HISTORIC AND DESIGN REVIEW COMMISSION

HDRC CASE NO: 2020-560
ADDRESS: 344 MARY LOUISE
LEGAL DESCRIPTION: NCB 6698 BLK 7 LOT 16
ZONING: R-6, H
CITY COUNCIL DIST.: 7
DISTRICT: Monticello Park Historic District
APPLICANT: Joe Cano/All Pro Services of Texas
OWNER: COH LARA HYE-YOUNG
TYPE OF WORK: Roof modifications
APPLICATION RECEIVED: May 08, 2021
60-DAY REVIEW: Not applicable due to City Council Emergency Orders
CASE MANAGER: Huy Pham
REQUEST:

The applicant is requesting a Certificate of Appropriateness for approval to replace a detached wood pergola with an attached rear roof addition for a covered rear patio.

1 EXISTING AND PROPOSED ROOF PLAN

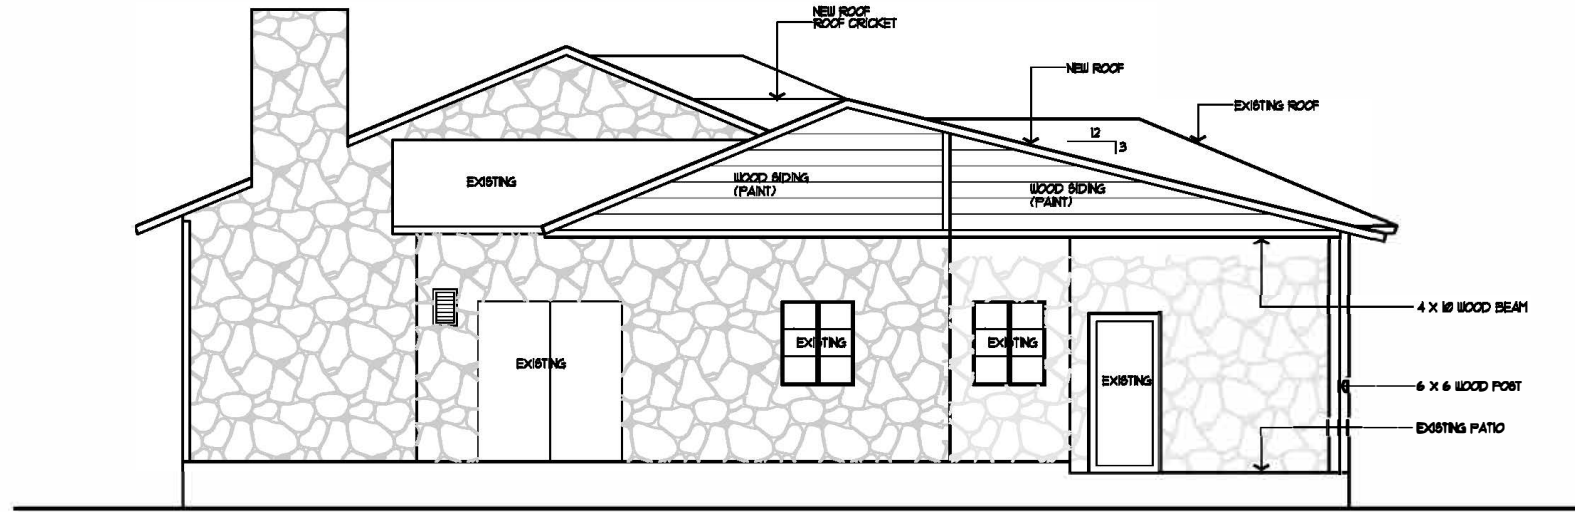
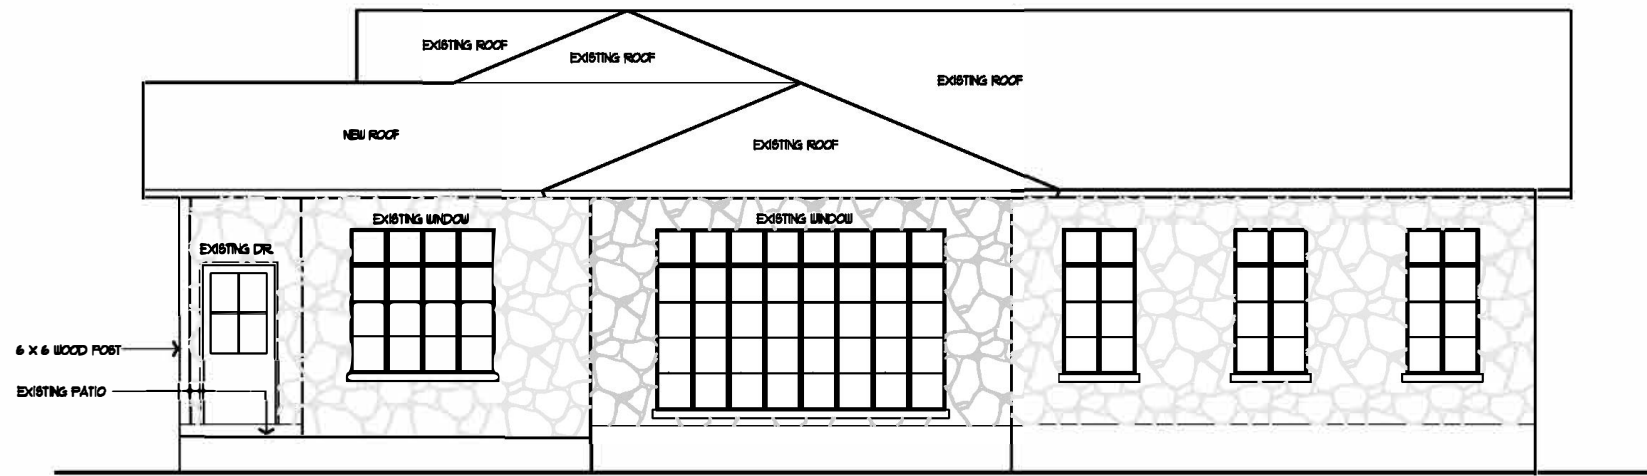
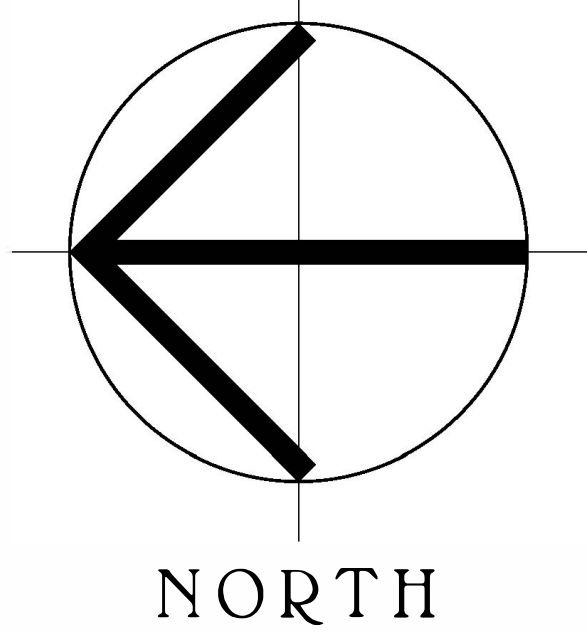
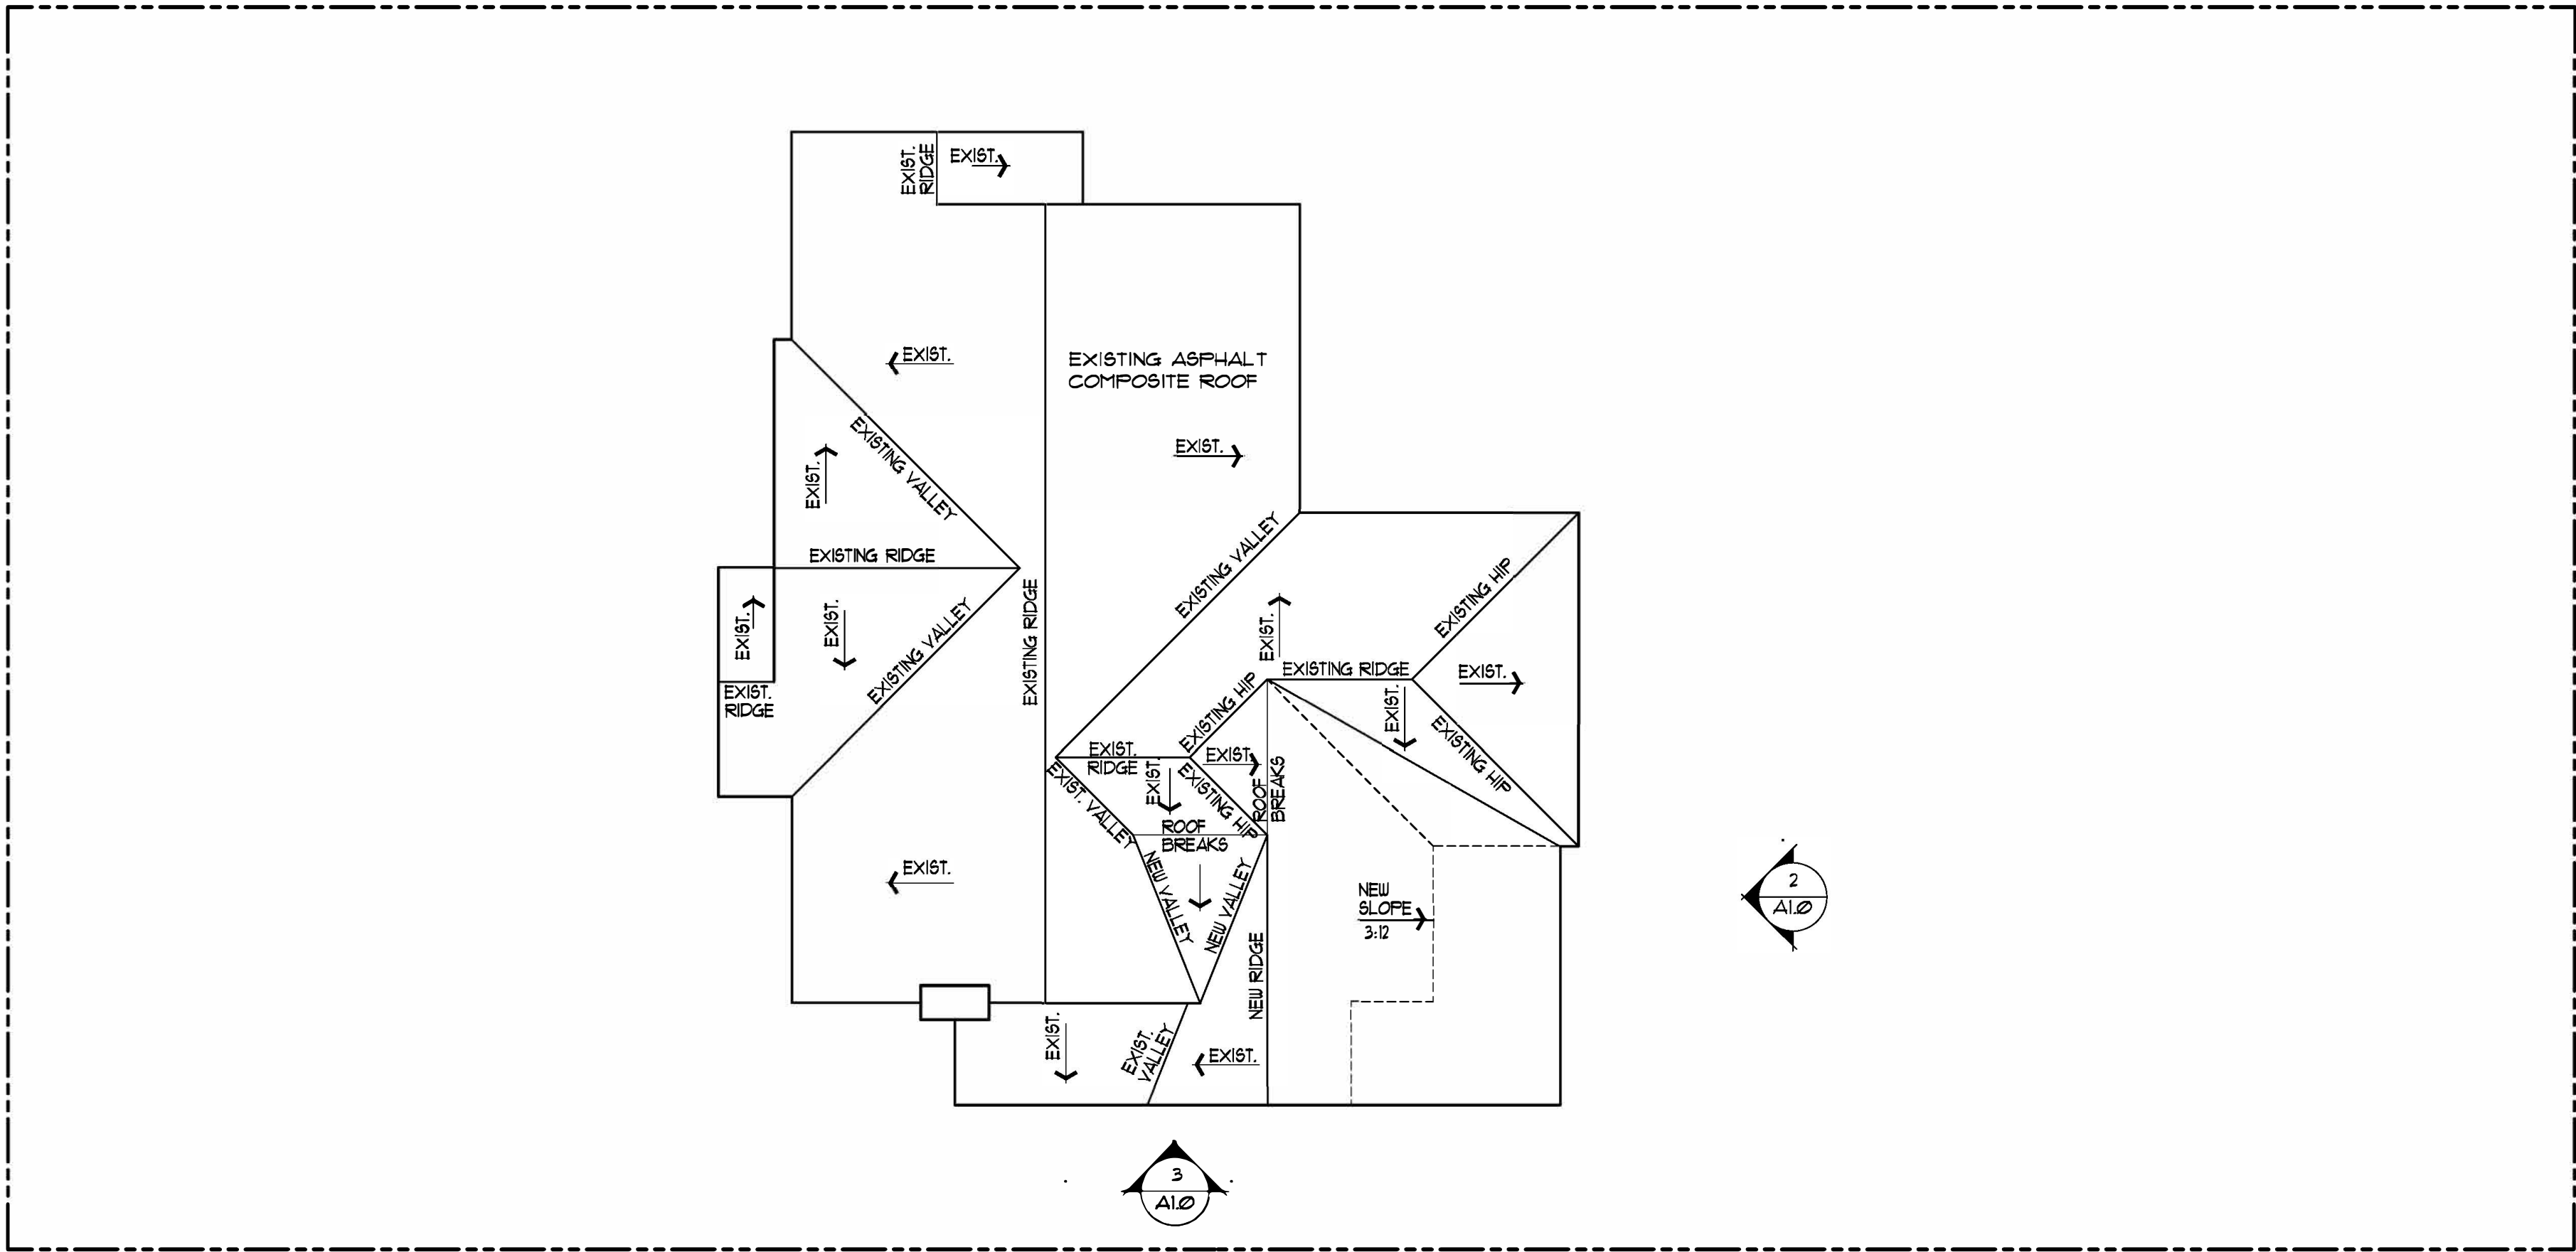
- d. REAR PATIO COVER -The applicant has proposed to replace a detached wood pergola with an attached rear roof addition for a covered rear patio. The porch cover will feature matching composition shingle, a vertical wood

beadboard turned gabled face, 6-inch square wood posts, will terminate at south rear and west side wall planes. Per the Guidelines for Additions 3.1.A. applicants should site residential additions at the side or rear of the building whenever possible to minimize views of the addition from the public right-of-way. Staff finds that setting the roof addition to the rear is appropriate.

- e. ROOF DESIGN – The applicant has proposed for the porch cover to feature matching composition shingle roof with 12-3 slope, a vertical wood beadboard turned gabled face, 6-inch square wood posts, will terminate at south rear and west side wall planes. Per the Guidelines for Additions 1.A.iii., application utilize a similar roof pitch, form, overhang, and orientation as the historic structure for additions. While the original design featured an atypical gable-in-gable form, staff finds the continuous wood lap cladding of the gable minimizes the visibility of the rear roof addition. Staff finds the proposed addition as proposed in the latest revision is appropriate considering the limitations of the rear roof forms and the visibility from the front right of way.

Staff recommends approval as proposed in the latest revised rendering (fully clad gable painted to match existing trim) based on the findings.

PHOTOSIM SUBMITTED 4/23/2021
TO ADDRESS GABLE APPEARANCE

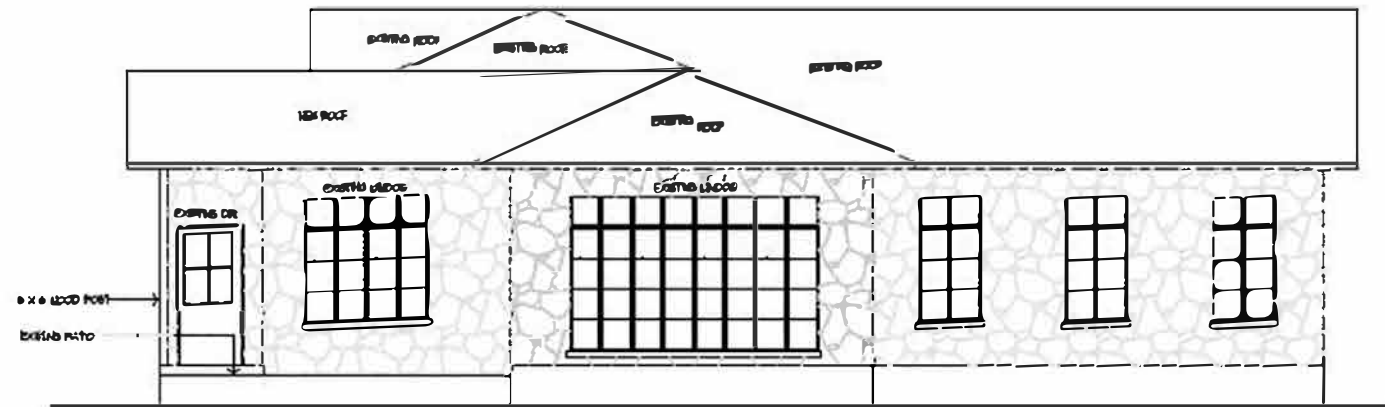
- c. DESIGN REVIEW COMMITTEE - At the January 20, 2021 hearing, the HDRC referred the case to a Design Review Committee meeting. The DRC met with the applicant on February 24, 2021. At the meeting, the applicant was able to explain limitations of installing traditional roof forms and slope in the rear of the property that would retain water rather than drain from the roof. The DRC understood the limitation but remained concerned about the asymmetrical gable and introduction of new siding material. The applicant has since revised the side gable profile to feature a fully clad gable with wood lap siding painted to match existing trim.
